CANADIAN OFFICE AND PROFESSIONAL EMPLOYEES UNION, LOCAL 378 (COPE 378)**INFORMATION REQUEST NO. 1 TO BC HYDRO****BC HYDRO 2015 RATE DESIGN**

Figure 5-12 Consumption Distribution of Select Residential Customer Segments, 20th to 80th Percentile of Annual Consumption in F2015

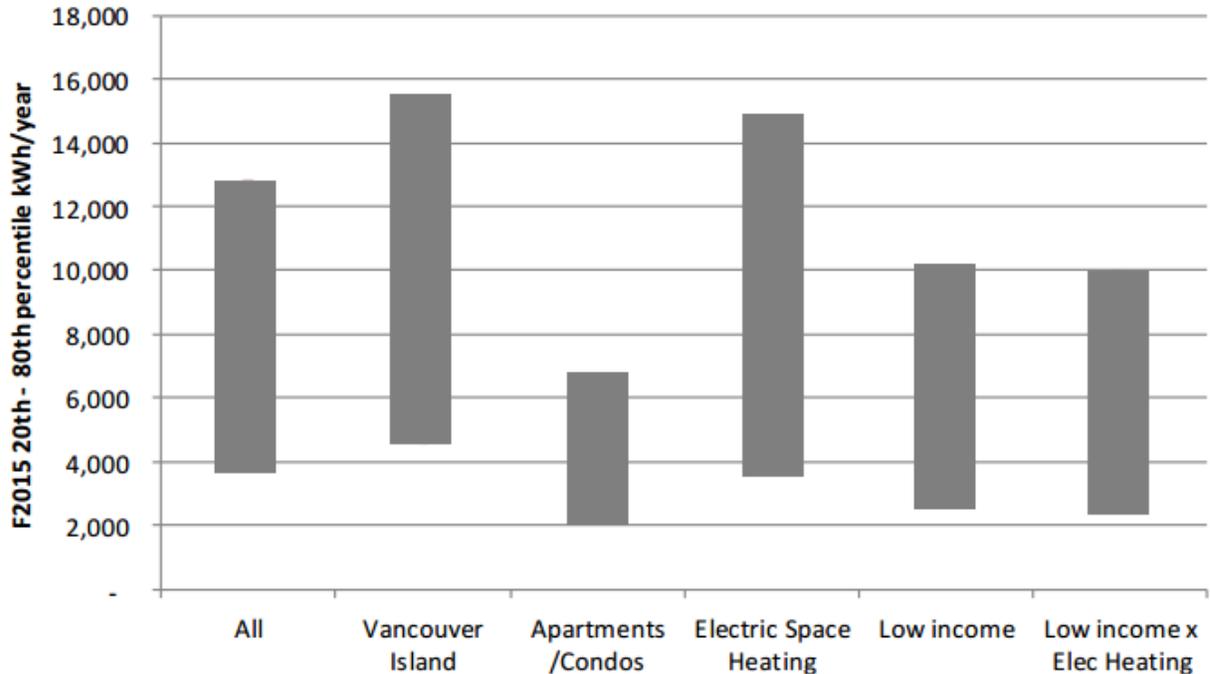
- 8.1 Please confirm that the median electricity consumption for low income customers is 43% higher than the median consumption for apartments and condos.

- 8.2 Please confirm that the consumption range for low income customers is much broader than the range for apartments / condos.
- 8.3 Please confirm that this higher median consumption is due to the significant number of low income customers who live in single family dwellings (SFDs).
